SAN ANTONIO WATER SYSTEM

ADDENDUM NO. 3

Northeast Service Center
Concrete Storage Bins Project
SAWS Project No. 10-7703

Plan: Base Plate Layout
350 bbl Silo

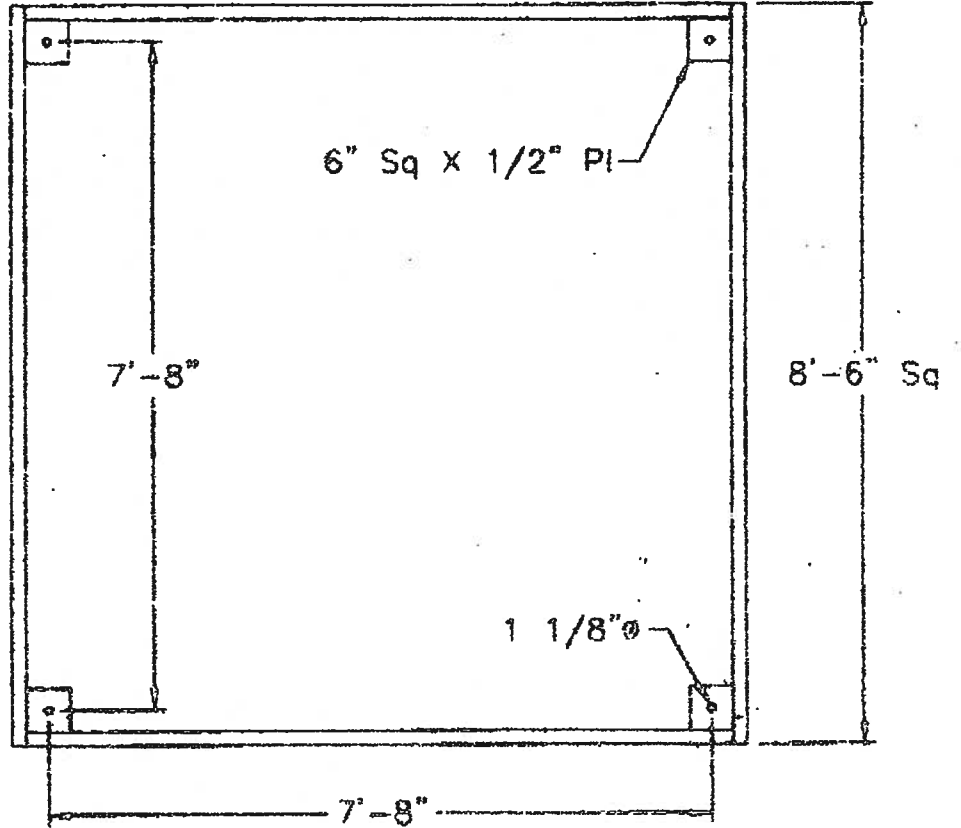
1. Included for general information is the Concrete Mixer/Silo Base plate layout for your use. See attachment.
